Docket Item # 2
BAR CASE # 2008-0106

BAR Meeting
July 23, 2008

ISSUE: Demolition/encapsulation

LOCATION: 309 North West Street

Figure 1: Rear of 309 North West Street, area proposed for encapsulation.

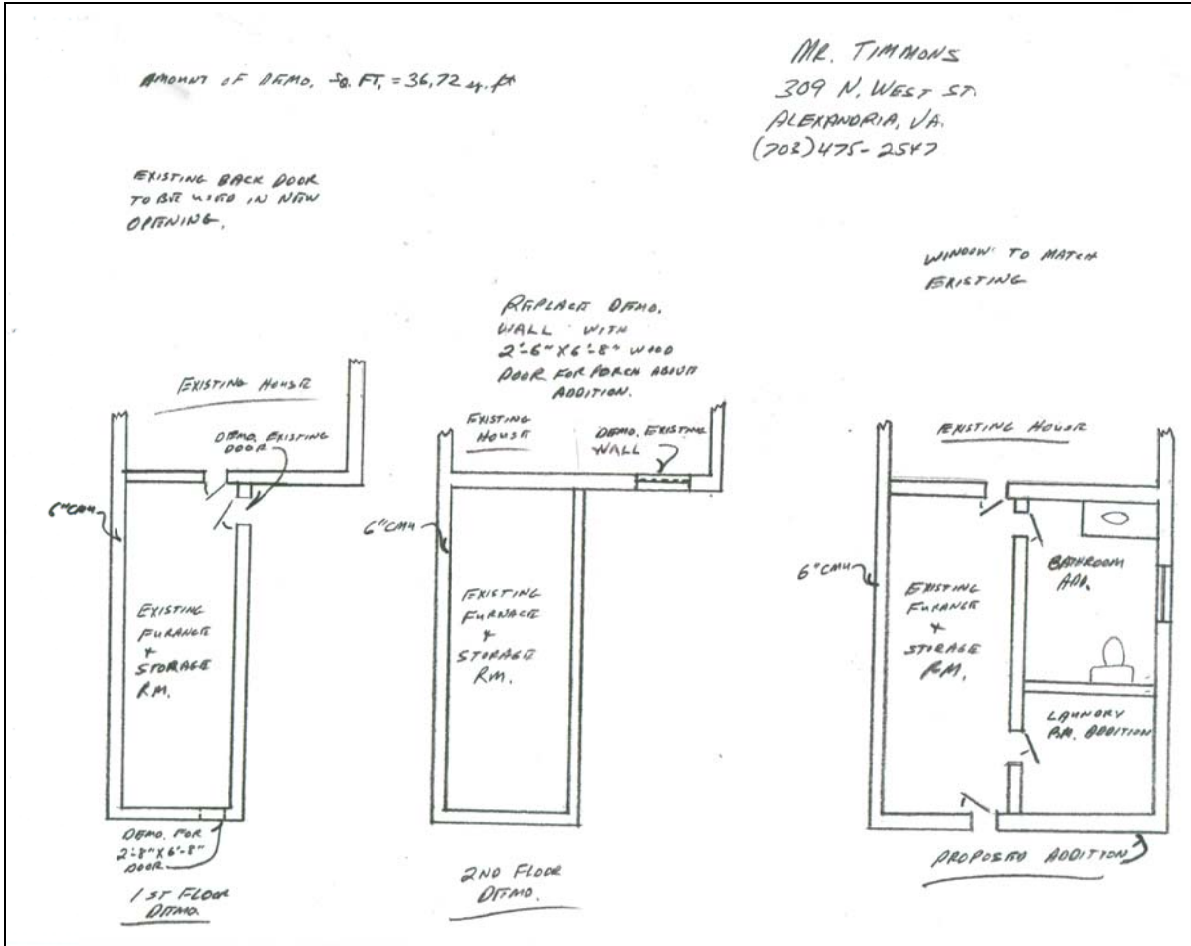
The applicant is requesting approval of a Permit to Demolish/Encapsulate portions of the dwelling at 309 North West Street to allow construction of a one-story rear addition measuring 10' x 6'. The proposed area for demolition/encapsulation includes a portion of the original rear ell of the building as well a portion of an existing concrete-block, one-story rear addition.

In the opinion of Staff, the proposed amount of demolition and encapsulation does not meet the above criteria. The proposal impacts only a small portion of the rear of the dwelling.

Staff recommends approval of the Permit to Demolish as submitted.
